Proposals for amendments to Annexes A and B of ADR: construction and approval of vehicles

Section 8.1.1: Number of trailers in a transport unit

Transmitted by the Government of Sweden¹

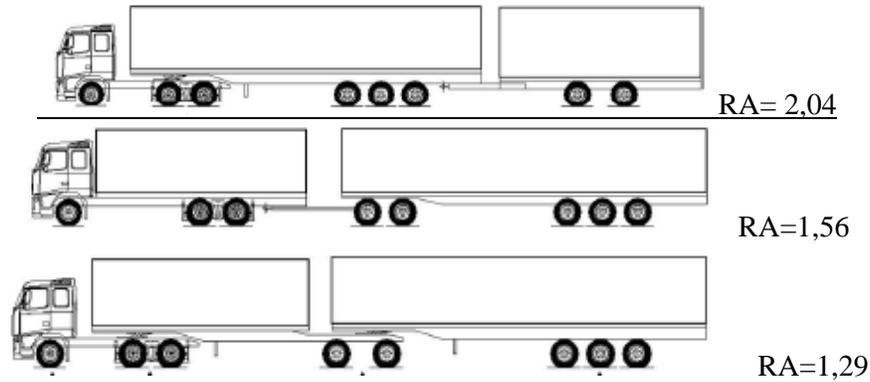
4. To enable such transport, Sweden has initiated multilateral agreement M198. Sweden cannot see any increased risk when three vehicles (two trailers) are used in a transport unit, even if the quantity of dangerous goods on the same transport unit may increase due to the use of long vehicles. In fact, the dynamic stability (RA) of a combination that consists of a tractor unit, a dolly and a semi-trailer (which is basically a tractor unit-full trailer combination) is proved to be better than the stability for a tractor unit-full trailer combination. This is mainly due to the longer wheelbase of the trailer (see illustration below).
